### STAFF REPORT FOR THE PLANNING COMMISSION

FILE NUMBER:	SUB-18-04/WAP-18-05
HEARING DATE:	August 21, 2019
REQUEST:	12-lot Subdivision at 22870 Weatherhill Road
APPROVAL CRITERIA:	Community Development Code (CDC) Chapter 12, Single-Family Residential Detached and Attached, R-7; Chapter 32, Water Resource Area Protection; Chapter 48, Access, Egress and Circulation; Chapter 55, Design Review; Chapter 85 Land Division General Provisions; Chapter 92, Required Improvements.
STAFF REPORT PREPARED BY:	Jennifer Arnold, Associate Planner

# ADDENDUM PLANNING COMMISSION STAFF REPORT August 21, 2019

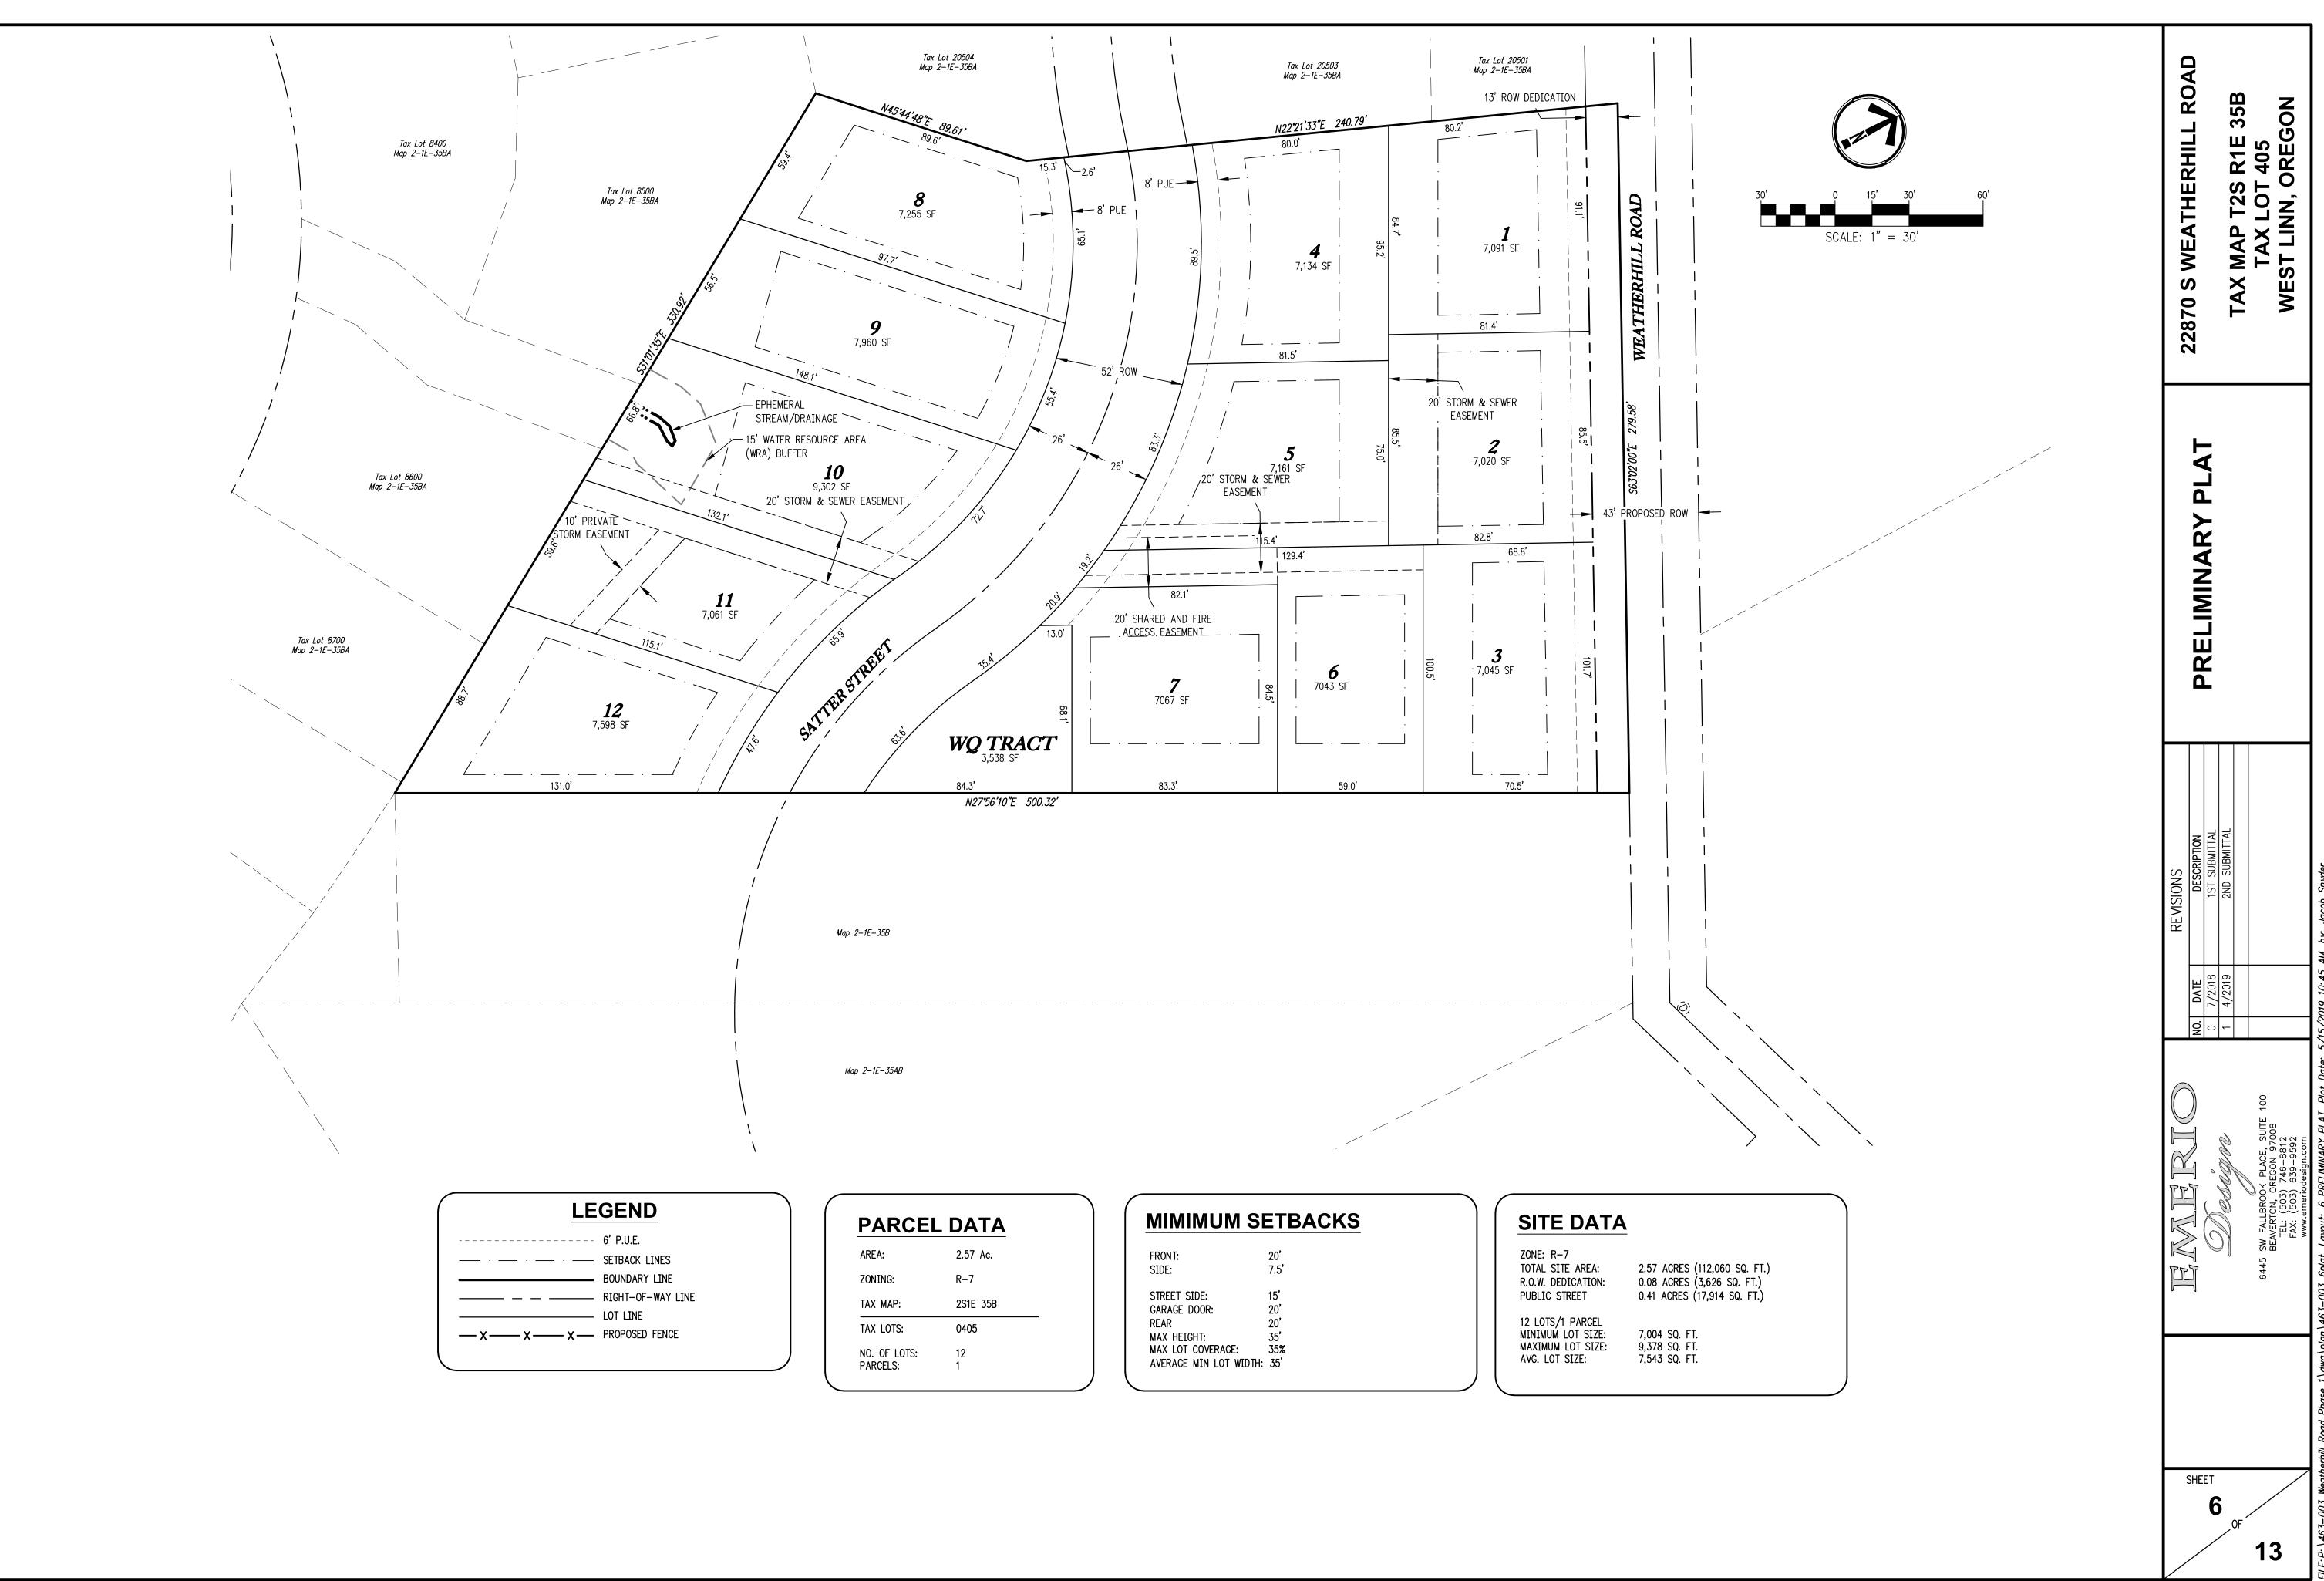
Staff Finding 39: The subject property is 2.11 acres (92,276 sq. ft.) after the right-of-way dedications. The subject property contains 77,545 square feet of land sloped 25% of less (See applicant's submittal sheet 5/13 'Slope Analysis Plan'). No lots are considered oversized and staff adopts the applicant's findings on page 30 of the applicant's supplemental submittal dated 5/23/19. This criterion is met.
